BIRMINGHAM CITY COMMISSION
SPECIAL LAND USE PERMIT

SUBJECT: **Public Hearing for Final Site Plan & Special Land Use Permit at 250 N. Old Woodward – Emagine Palladium and Ironwood Grill**

EMAGINE PALLADIUM AND IRONWOOD GRILL
250 N. OLD WOODWARD
SPECIAL LAND USE PERMIT
2015

SUBJECT: **Final Site Plan & Special Land Use Permit Review**
250 N. Old Woodward – Emagine Palladium Theatre and Ironwood Grill

"HALO" Illuminated Section detail / Typical LED

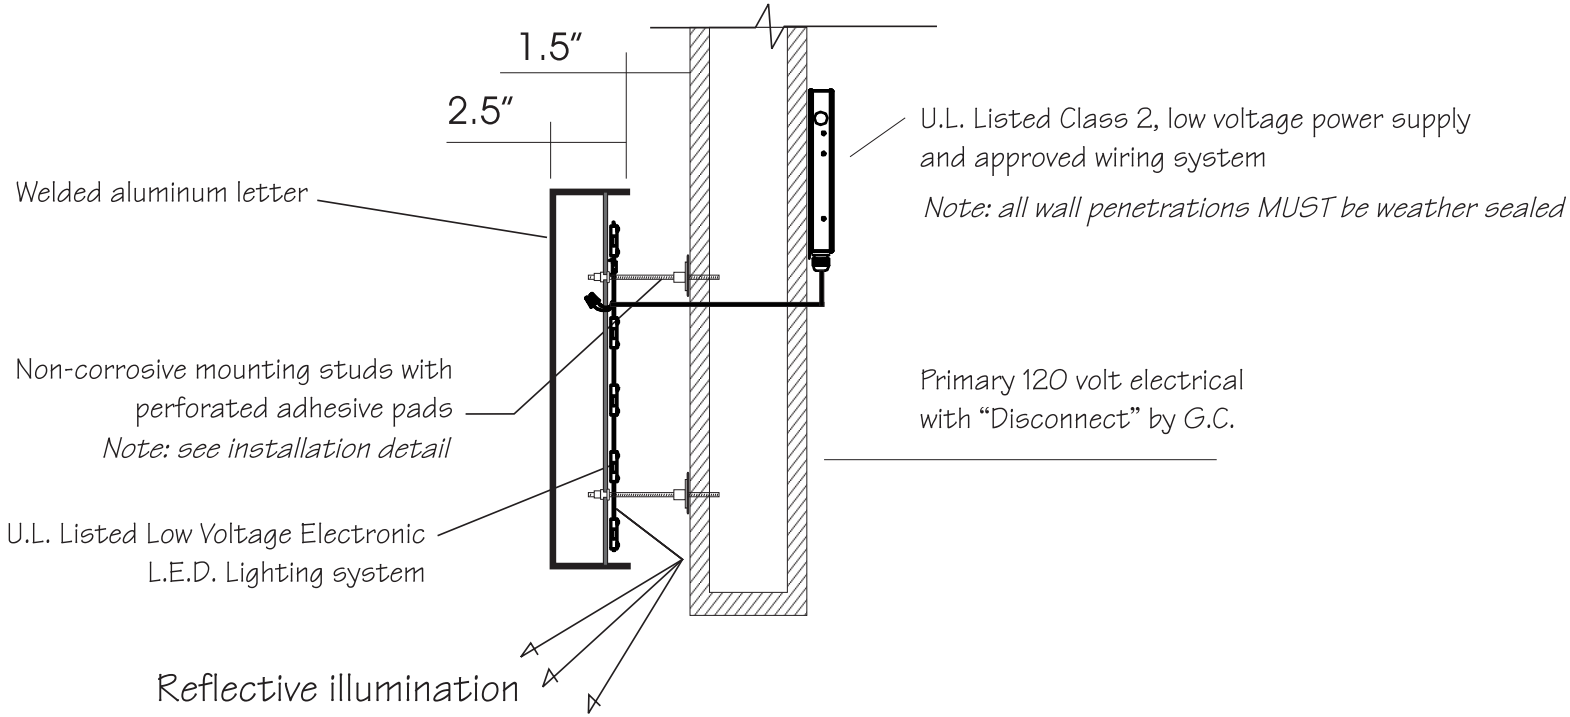
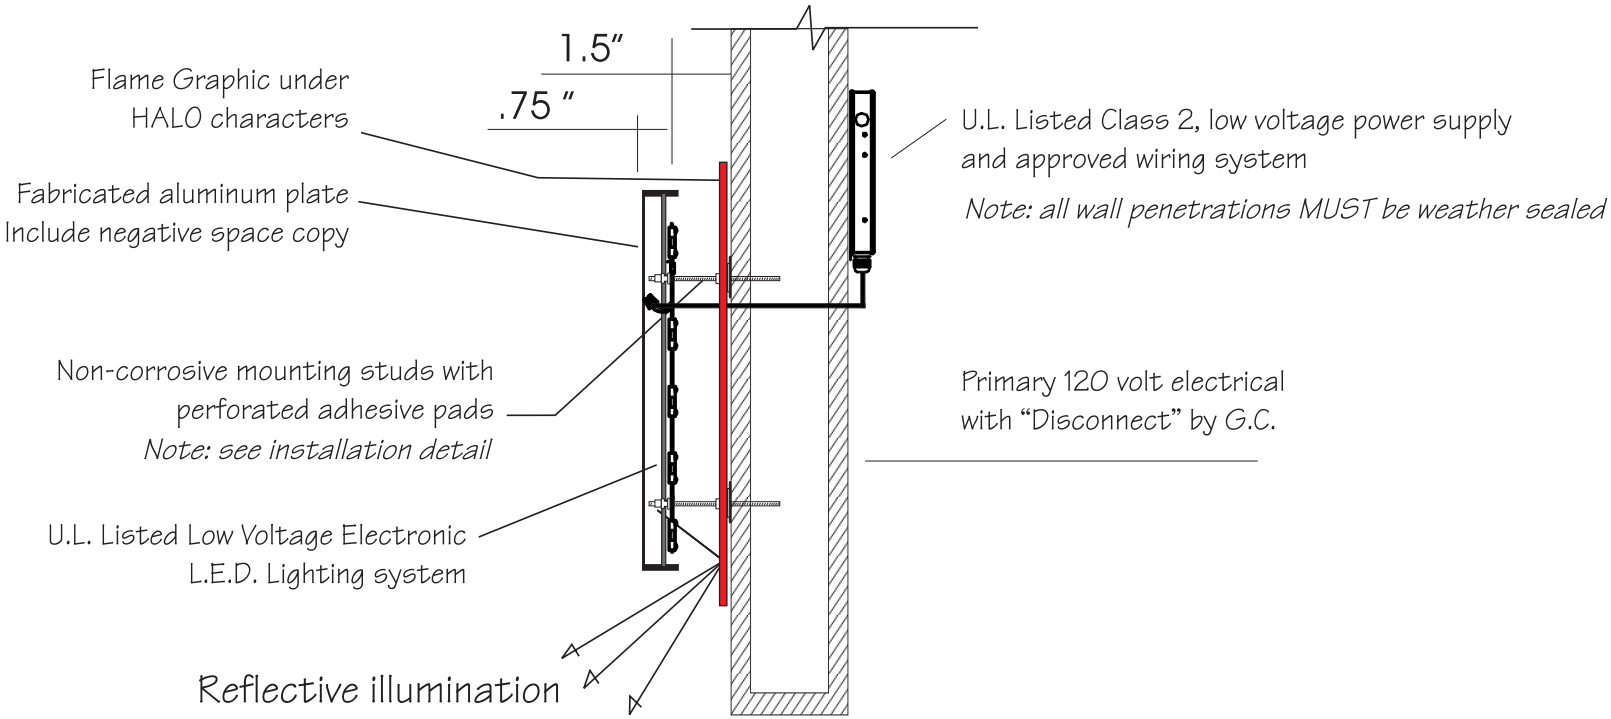
Article 3 of the Zoning Ordinance also provides that external signs shall not be internally illuminated, but may be back lit or externally lit. The applicant has now provided lighting details for each of the signage elements. All signage is proposed to use low voltage electronic LED lighting mounted behind signage, to reflect off background and subtly illuminate each element with a halo effect. **However, due to the design of the Ironwood Grill signs including open cut lettering, the LED lighting must be mounted so that it is not visible through the open cut area. It must be mounted to a solid portion of the aluminum panel from which the letters are open cut.**

8. LED lighting on the Ironwood Grill sings must be mounted so that it is not visible through the open cut area.

SHEET DESCRIPTION:
NANAWALL DETAILS

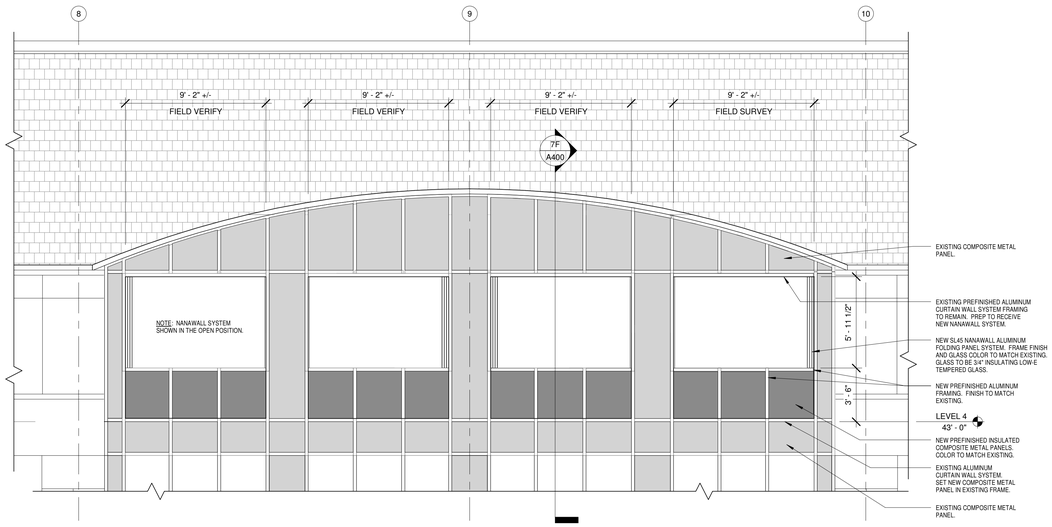
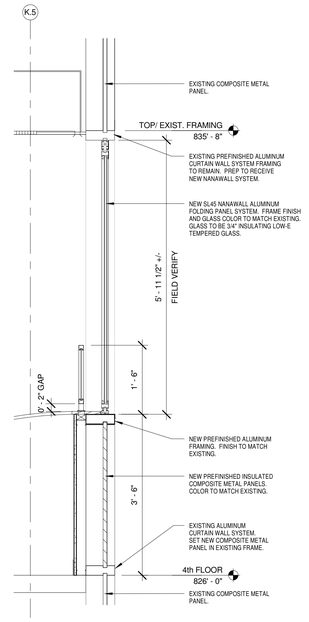
to be mounted up to 2" from the top of the metal panel and extend 1.5' above. No other details are provided, so it is unclear what this is, and of what material it is made. The plans no longer propose the use of spandrel glass, and metal panels are permitted for use on balconies and railings in accordance with Article 3, section 3.04(E) of the Zoning Ordinance.

3. Provide all colors for the proposed metal panels, Nanawall system and aluminum framing, and provide details on what appears to be a railing on top of the metal panel guard rail on the fourth floor of the south elevation;

4. The fire stopping system must be maintained or replaced with a UL approved system where the Nanawall is proposed;
5. Provide material specifications for the background sign panel on the marquis, and clarify all sign colors;
